BURLINGTON DEVELOPMENT REVIEW BOARD

Tuesday, September 15, 2015

BURLINGTON DEVELOPMENT REVIEW BOARD Tuesday, September 15, 2015, 5:00 p.m. Contois Auditorium, City Hall, 149 Church Street, Burlington, VT AMENDED AGENDA

2 Reflected Ceiling Plan
1/4" = 1'-0"

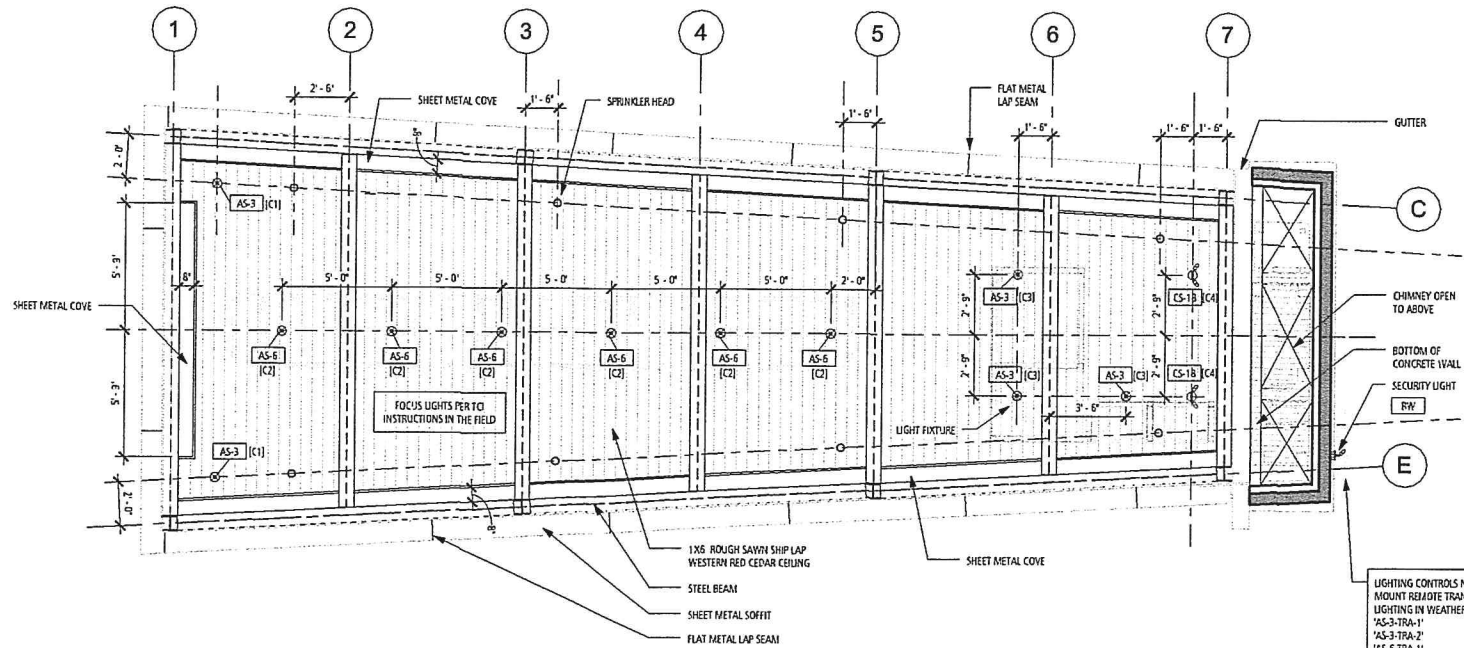
The pavilion will be illuminated, and lighting fixture details have been provided. The fixtures themselves are acceptable, but there is no photometric plan depicting illumination levels within the pavilion. One is needed in order to confirm acceptable illumination levels. **(Affirmative finding as conditioned)**

1. **Prior to release of the zoning permit**, a photometric plan for pavilion lighting shall be provided in conformance with the standards of Sec. 5.5.2, subject to staff review and approval.
2. **Prior to release of the zoning permit**, the applicant shall obtain written approval from the Burlington Fire Marshal for the proposed outdoor grille.
3. It is the applicant's responsibility to comply with all applicable ADA requirements.
4. All new construction is required to meet the Guidelines for Energy Efficient Construction pursuant to the requirements of Article VI. Energy Conservation, Section 8 of the City of Burlington Code of Ordinances.
5. Standard Conditions 1-15.

option 2 -
cross gable

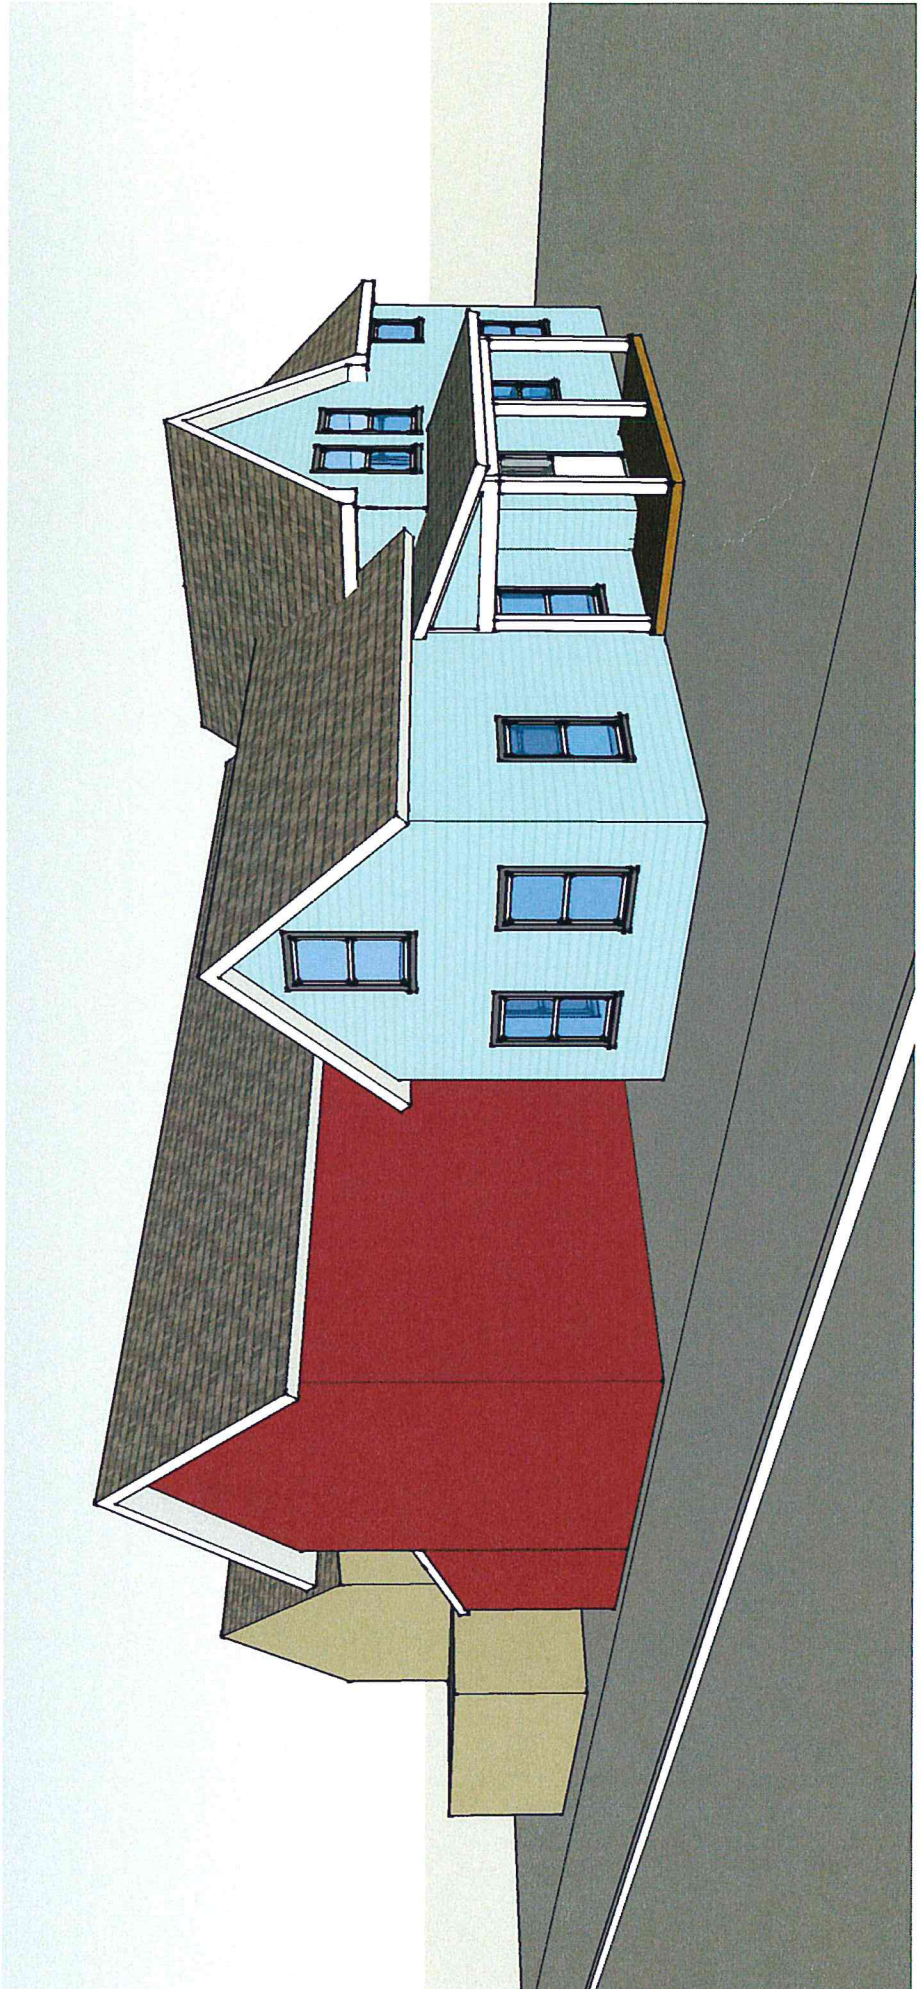
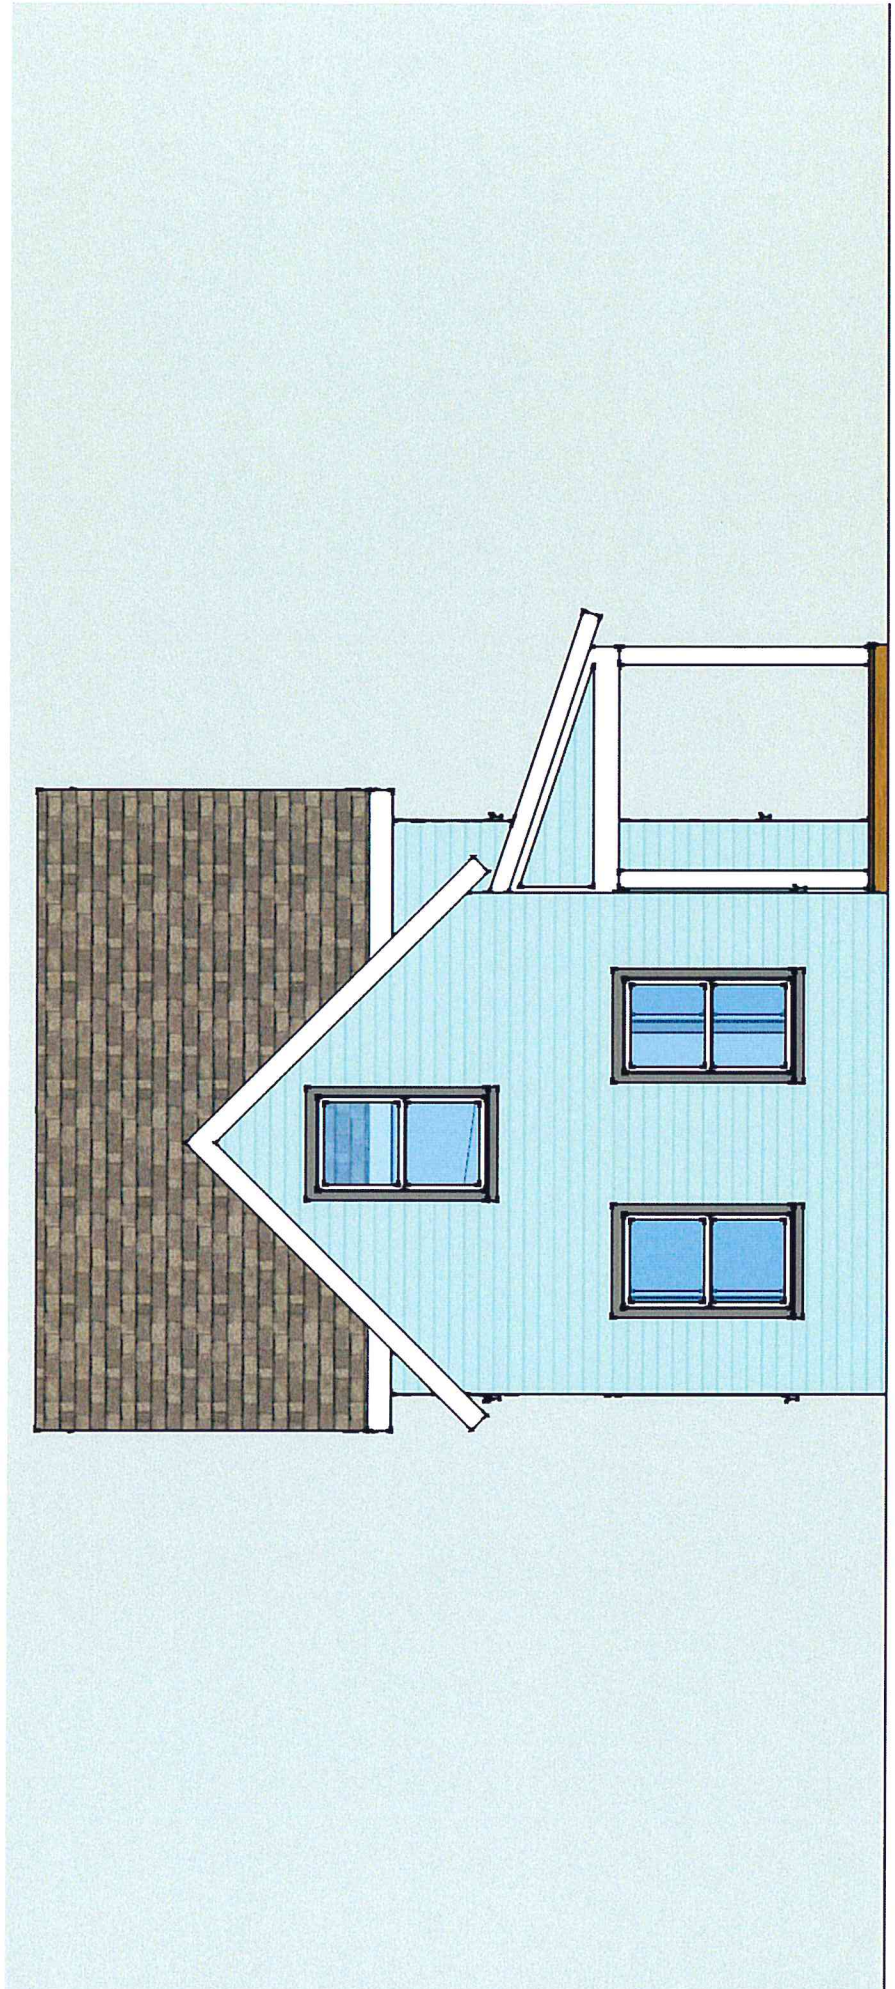
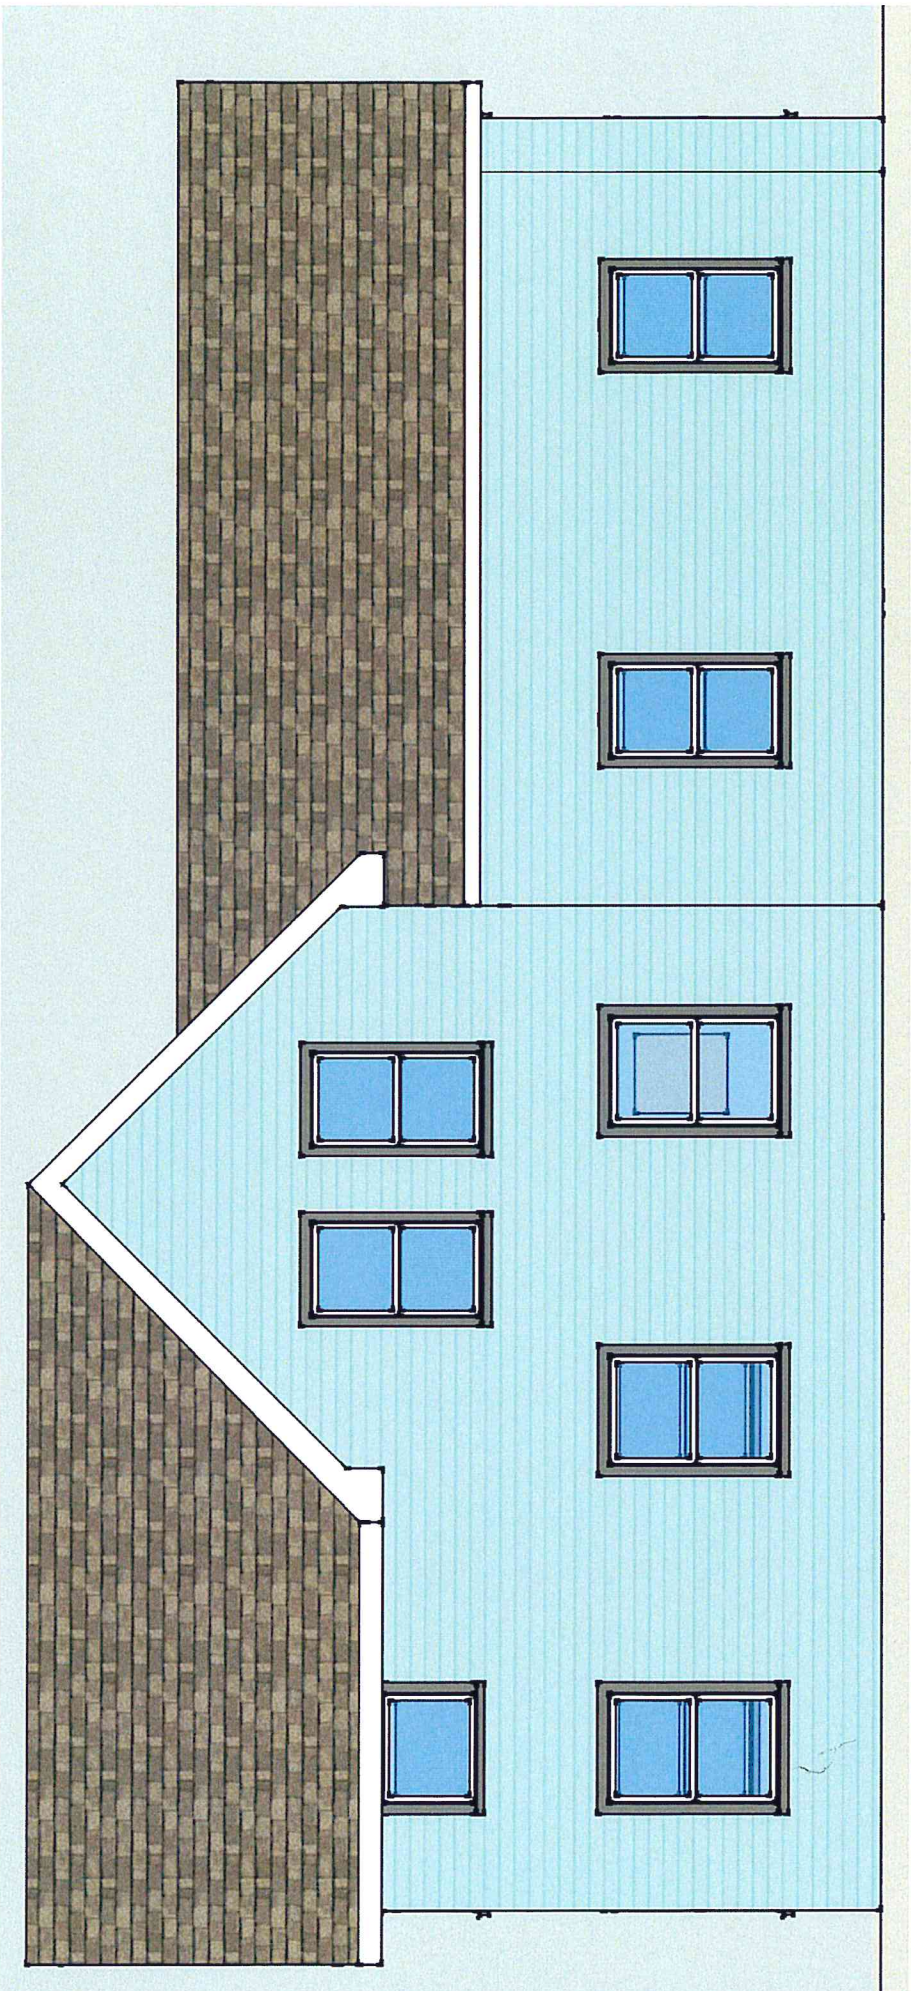
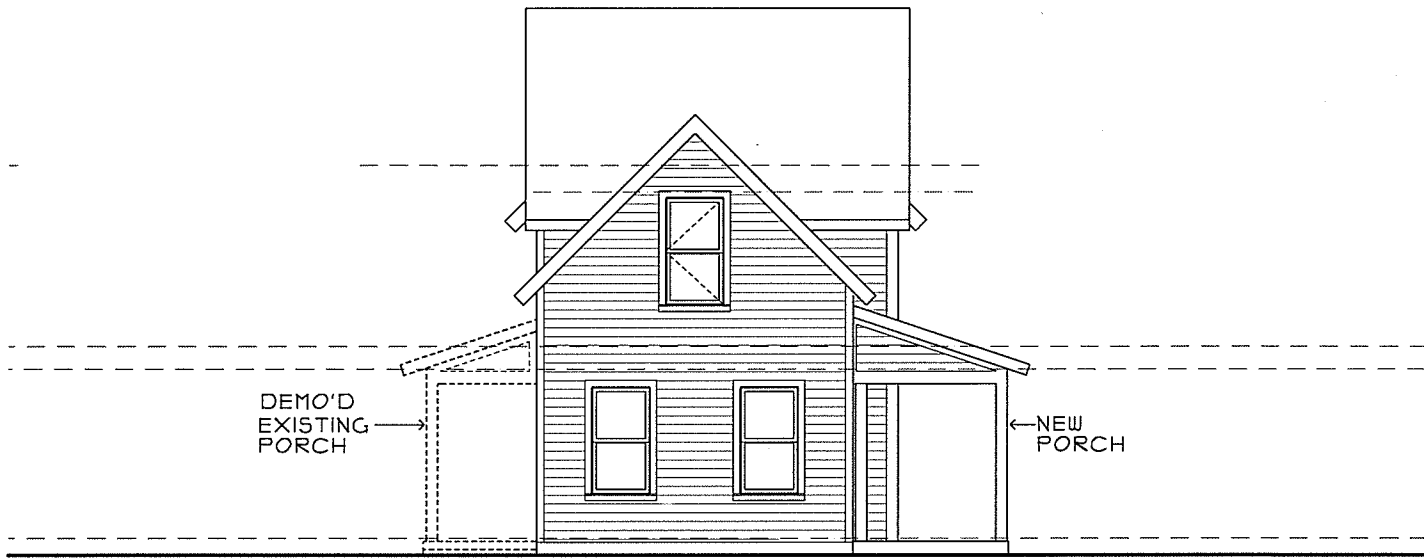
The addition is proposed to replace a single story addition at the rear with a two story structure. Although oriented behind the primary structure as is typical of many residential additions, it is proportionally much larger than the existing structure. Option 2 (with a cross-gable) helps to ameliorate the difference in scale.

Revised elevations give an enhanced image of the proposed addition, drawn professionally to better illustrate scale and proportion. Option 2 (as identified in revised plans) presents a cross gable plan that would provide a similar amount of new habitable area while diminishing the visual impact of the abrupt roof height proposed for the rear. It also reflects a continued eave line on the rear that more closely associates with the front part of the building. These are visual tricks that soften what might be a brusque change in massing and scale, and make clear the progression of building growth. Particularly in the Old North End, these multi-gabled, multiple roofline buildings are the character of the neighborhood, and Option most closely reflects that. The Design Advisory Board found Option 2 to meet this standard. **Affirmative finding.**

The principle building will remain, but the key is to minimize the visual impact of the larger rear addition. A new option has been provided; one that will enhance to livability of the residence. The roof plan illustrated in Option 2 is successful in minimizing that sudden disparity between the small size of the principle mass with the new addition. **Affirmative finding.**
